PIPELINE SAFETY & RELIABILITY PROJECT (PSRP) (A.15-09-013)

(DATA REQUEST ORA-66)

Date Requested: January 19, 2017 Date Responded: February 16, 2017

RESPONSE 7:

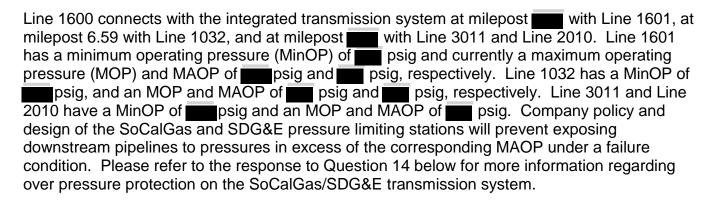
QUESTION 7:

Please provide a listing of the interconnection points Line 1600 would have with transmission pipelines south of Rainbow Station. For each interconnection point provide:

- a. The name and designation of the interconnecting line;
- b. The maximum allowable operating pressure (MAOP) of the interconnecting line;
- c. The maximum and minimum operating pressure of the interconnecting line;
- d. At each interconnection point, what pressure and for how far Line 1600 would experience that pressure if the pressure limiting valve at the interconnection point failed.
- e. The milepost on Line 1600 of each interconnecting line.

This response contains confidential information (shaded in gray) and is provided pursuant to Cal. Pub. Util. Code § 583, General Order 66-C and D.16-08-024. Accordingly, a confidentiality declaration is included with this submission.
